Determination 2018/040

Regarding the refusal to issue a building consent in respect of a fixed glazing system at 6 Island Bay Road, Beach Haven, Auckland

Summary

This determination considers whether the authority correctly exercised its powers in refusing to issue a building consent for a new house with a fixed glazing system.

Figure 2: Head and sill detail of the original fixed glazing system (not to scale)

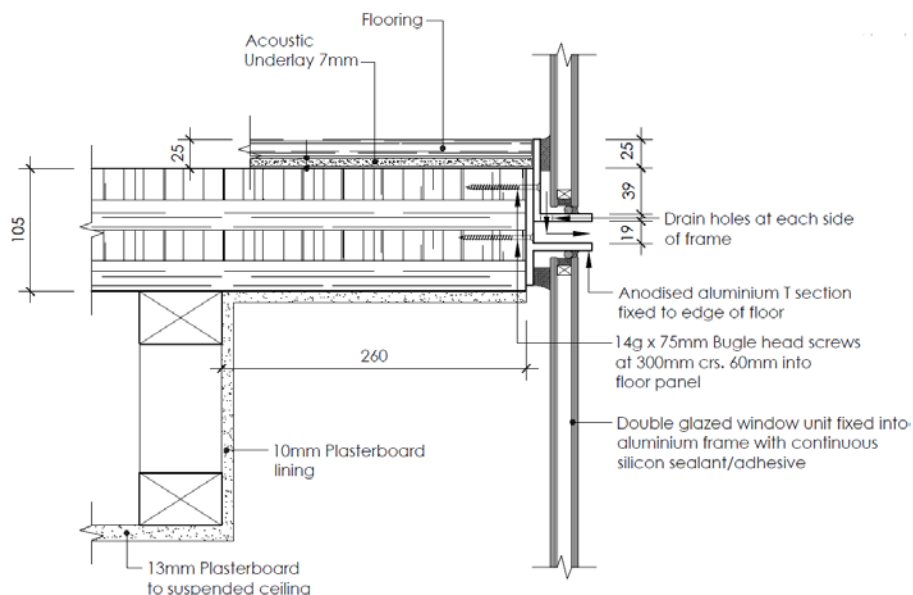
- 6.5.1 The applicant provided multiple details showing the original fixed glazing system junctions at head, sill and jamb. I make the following comments regarding the consent drawings submitted to the authority:
- The consent details identify a non-structural sealant instead of one of the proposed structural sealants. The specified non-structural sealant is used to seal joints to prevent the penetration of water, but is not intended to support double insulated glazing units, and the specification specifically states it must not be used “[w]ith structural glazing or floor joints.”
 - As well as the lack of structural sealant, the details in the consent drawings also vary from the glazing manufacturer’s detail. No structural tape is identified and significantly less structural and waterproof sealant is proposed to the sill and

head junctions than what is shown in the glazing manufacturer's detail. I note a jamb junction was not provided by the glazing manufacturer.

- The sizing of the aluminium joinery appears to vary and only some details clearly identify the specific size of the joinery.
- The glazing manufacturer's PS1 specified toughened glazing whereas the consented drawings instead specify low E laminated glazing.

Figure 3: Typical sill detail of the modified fixed glazing system (not to scale)

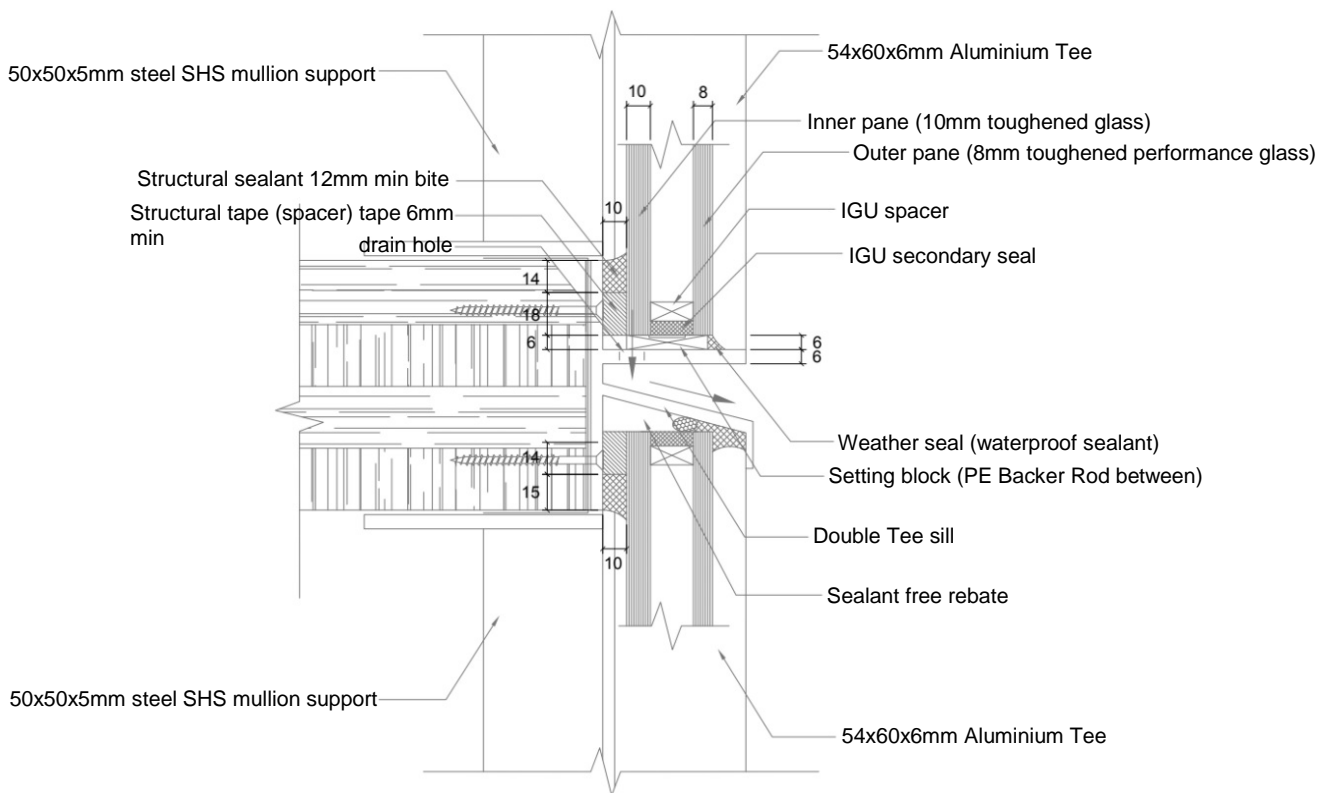
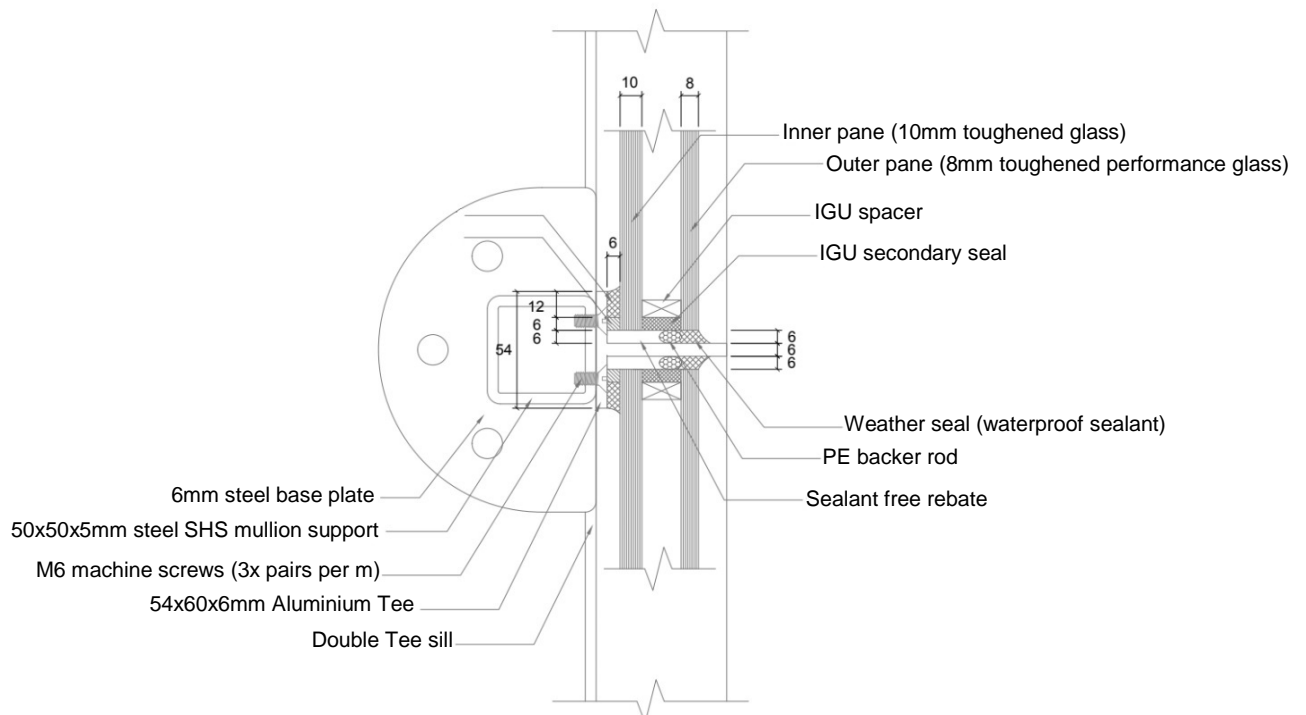
- the modified drawings did not consistently show the 50x5x5mm SHS mullion supports
- the glazing manufacturer’s PS1 identified one type of structural sealant, but the drawings referred to a different type of structural sealant
- references to structural sealant being applied over backing rod should be amended to specify it over the structural glazing tape
- the specification for the structural glazing tape had not been provided
- the revised drawings had not been updated to incorporate the applicant’s structural engineer’s calculations

- there is no detail indicating how the SHS mullion supports would be fixed to the top and bottom of cross laminated timber floor panels
- the structural glazing tape seemed to be inadequately sized
- there was a lack of details describing the connection or sealing of vertical elements of the aluminium joinery to the horizontal joinery.

5.5.1 Based on the proposed design the available width for the structural glazing tape is 4.5mm. The expert architect noted suitable tapes appear to be 10.5mm wide or more, and it is unclear whether a 4.5mm wide tape would provide sufficient fixing for the glass while the structural sealant is curing.

- the drawings needed to be amended to clarify 50x50x5mm SHS posts will be fitted behind all mullions
- new fixing details and calculations are required where the SHS posts will be fixed to the bottom and top of the cross-laminated timber floor
- the edge fixing distances required increasing
- a calculation check of the sill joinery, noting the joinery is subject to bending
- the calculations need to take into account that the fixings are subject to shear force due to the weight of the glazing, and in some instances also subject to tension
- a calculation of the structural bite to determine the length of the sealant
- an alteration to the mullion design to allow sufficient width for both the glazing tape and structural sealant as specified.

- The mullion size has been increased to 54mm to allow for additional tape and sufficient structural sealant. The structural tape does not provide “long term structural qualities”, instead it is a “spacer” that determines the structural sealant thickness.

- all drawings revised to show mullion supports
- amended text error referring to backing rods
- increased edge distance of sill fixings into the cross-laminated panels to 21mm
- sill drain holes shown as specified
- additional mullion to frame details to clarify sealant and connection details.

- The applicant has revised his drawings and documentation to specify one type of structural sealant.
- The glazing manufacturer's PS1 has been revised to identify one structural sealant option, and confirmed it could be used to "seal glass to tiles in wet areas". The glazing manufacturer "approved" the modified fixed glazed system drawings.

- 6.7.4 The applicant has now revised the drawings to be consistent with the structural drawings and calculations provided, as well as the glazing manufacturer's design. Also, the applicant has revised the drawings to rectify the issues noted in the draft determination and by the experts. However, the drawings will need to accommodate the necessary revisions to the structural design of the fixed glazing system, as identified by the applicant's engineer.
